**ACTION ITEM
BOARD OF SUPERVISORS**

ISSUE Request VDOT to Consider Design Features with the I-95 Interchange at Courthouse Road

Courthouse Road Interchange

**A RESOLUTION TO REQUEST THE VIRGINIA DEPARTMENT OF
TRANSPORTATION CONSIDER AND EVALUATE CERTAIN
DESIGN FEATURES ASSOCIATED WITH THE NEW INTERSTATE
95 INTERCHANGE WITH COURTHOUSE ROAD**

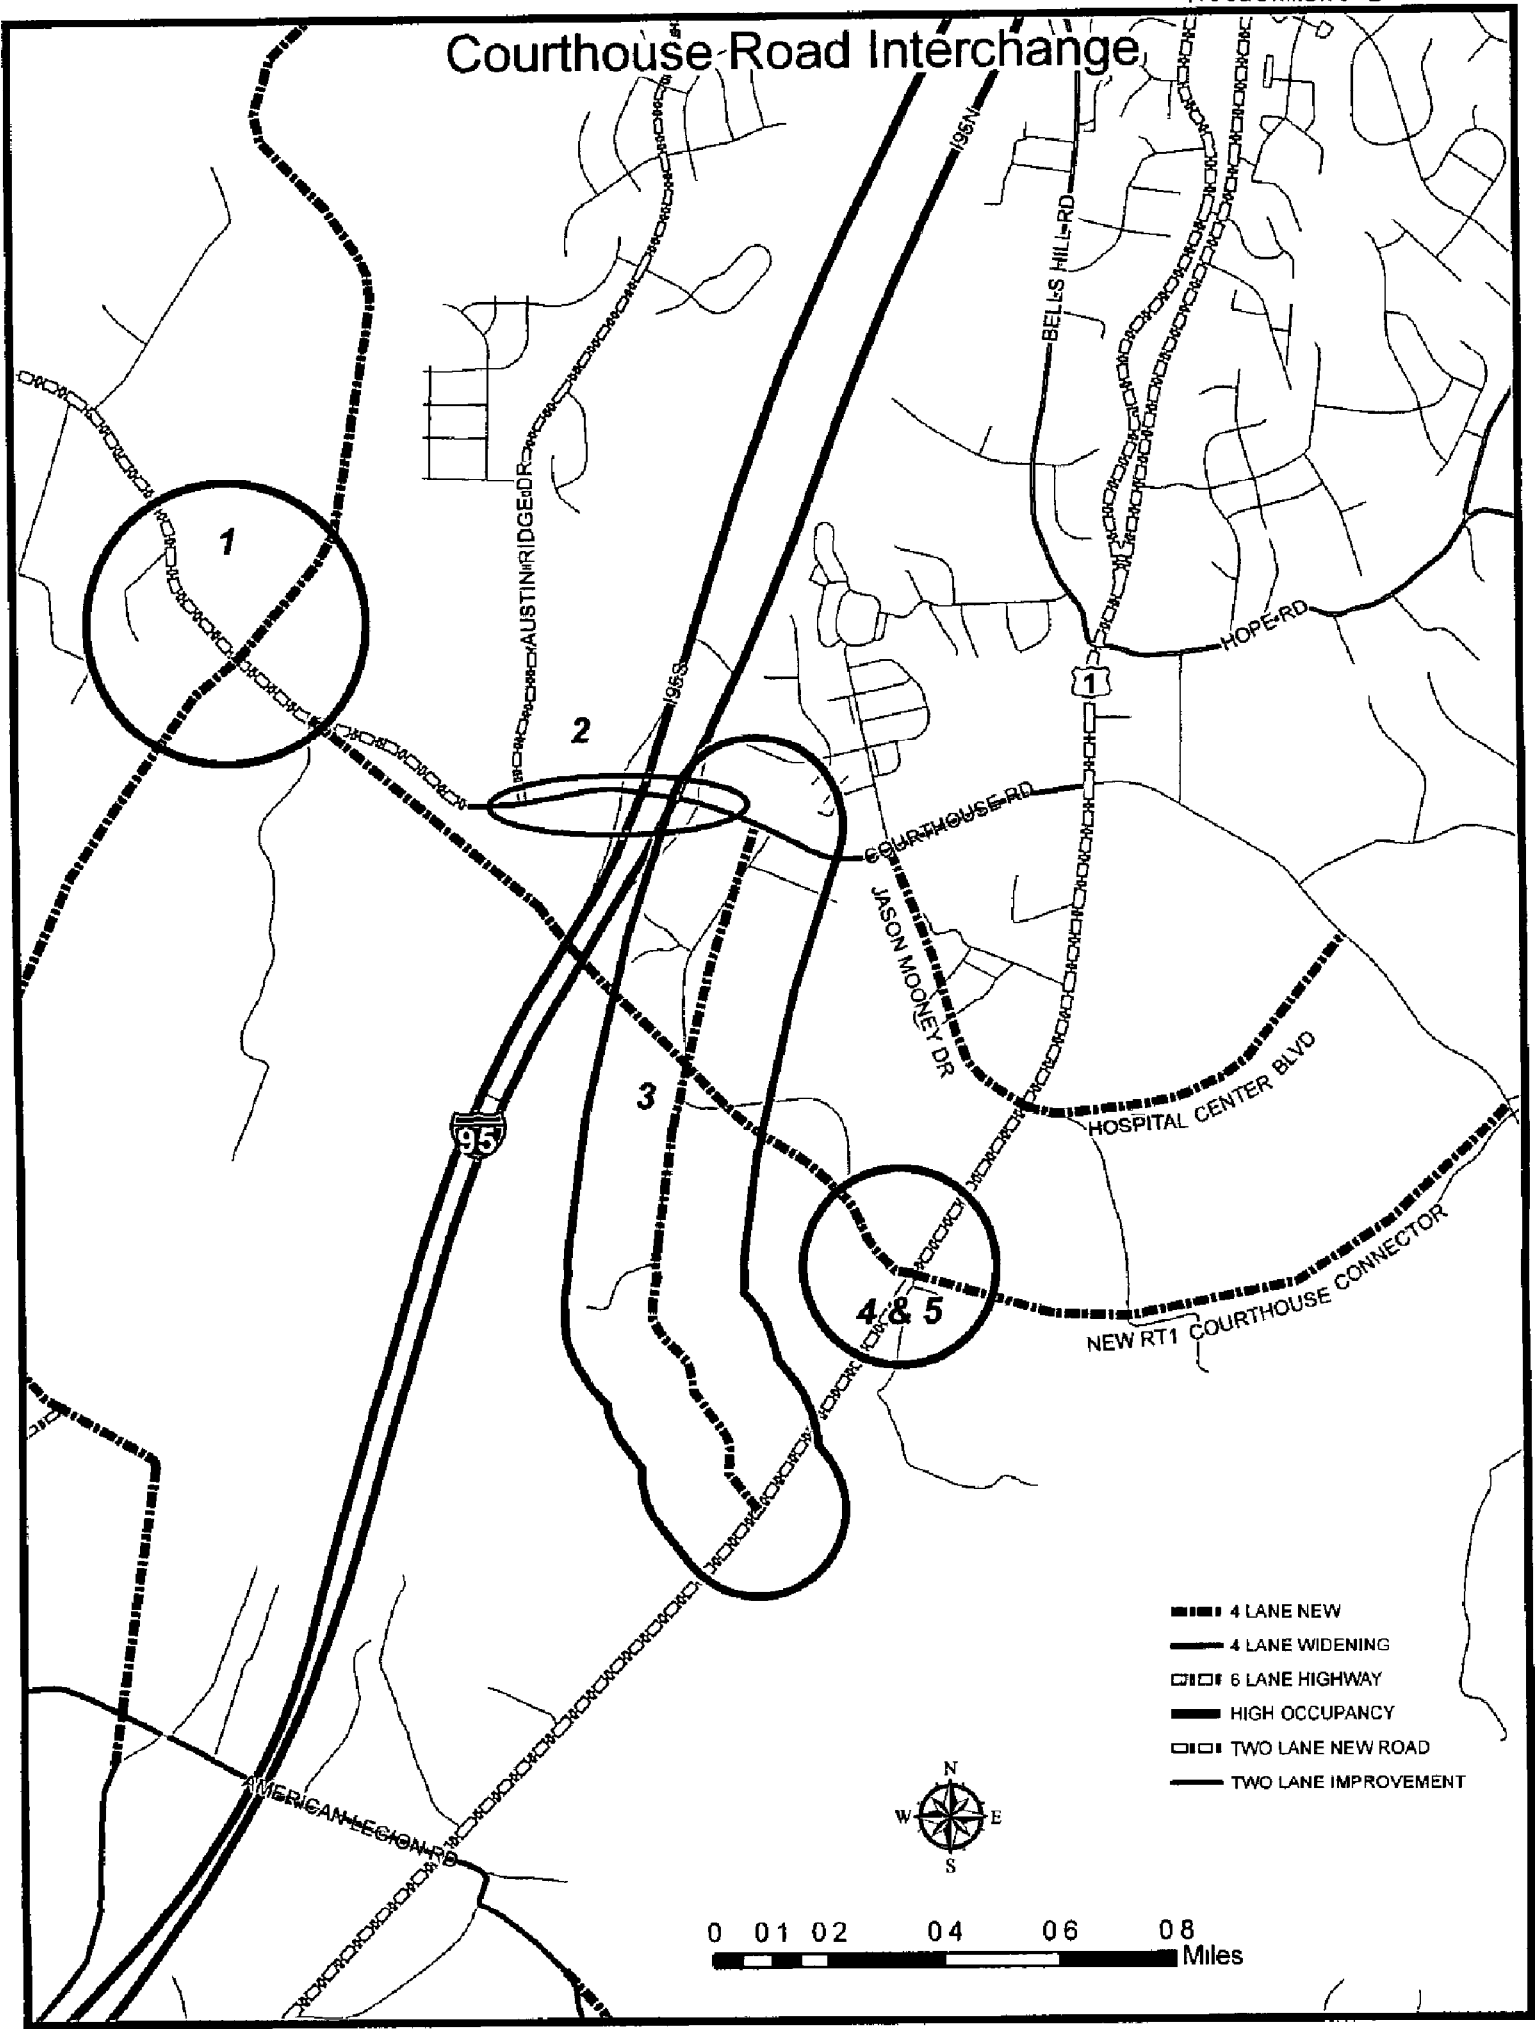
1. Along the new Interstate 95 connector road, allow for the future intersection with the extension of Mine Road, identified in the County Transportation Plan as a future 4-lane divided road (See Area 1 on attached map)

2. Maintain the current connection from the Austin Ridge Area to the Courthouse Area (See Area 2 on attached map)
 - a. Maintain the existing segment of Courthouse Road that crosses under Interstate 95

- b. Maintain the existing Austin Ridge Drive/Courthouse Road intersection
 - c. Maintain existing Courthouse Road between Austin Ridge Drive and Mine Road extended and integrate this segment into the design of the new Interstate 95 connector road

3. Maintain a north/south road between Jefferson Davis Highway and Interstate 95. It appears the current north/south connection along Wyche Road will likely be eliminated with the new interchange (See Area 3 on attached map)

- a. Provide a crossing of the new Interstate 95 connector road
 - b. Allow access between the north/south road and the new Interstate 95 connector road to allow alternate access to Courthouse Road other than by way of Jefferson Davis Highway

- c The north/south road should be grade-separated if this segment of the new Interstate 95 connector road is not conducive to a signalized intersection

- d Future design concept drawings should show how parcels within the interchange footprint will be provided with continued access to the public street network

- 4 Connect the new Interstate 95 connector road to Jefferson Davis Highway in a location south of the Stafford Hospital Boulevard in the vicinity of Peake Lane (See Area 4 on attached map)

- 5 Improvements need to assess and mitigate any impacts this project would have on Jefferson Davis Highway. These improvements should also extend north to integrate with the boulevard design recommended by the Courthouse Area Redevelopment Plan and continue the streetscape improvements constructed in conjunction with the VDOT enhancement grant and associated proffers (See Area 5 on attached map)

- 6 Design commuter lots into the project that allow for easy access to and from Interstate 95 and have capacity equal to or greater than the current commuter lot
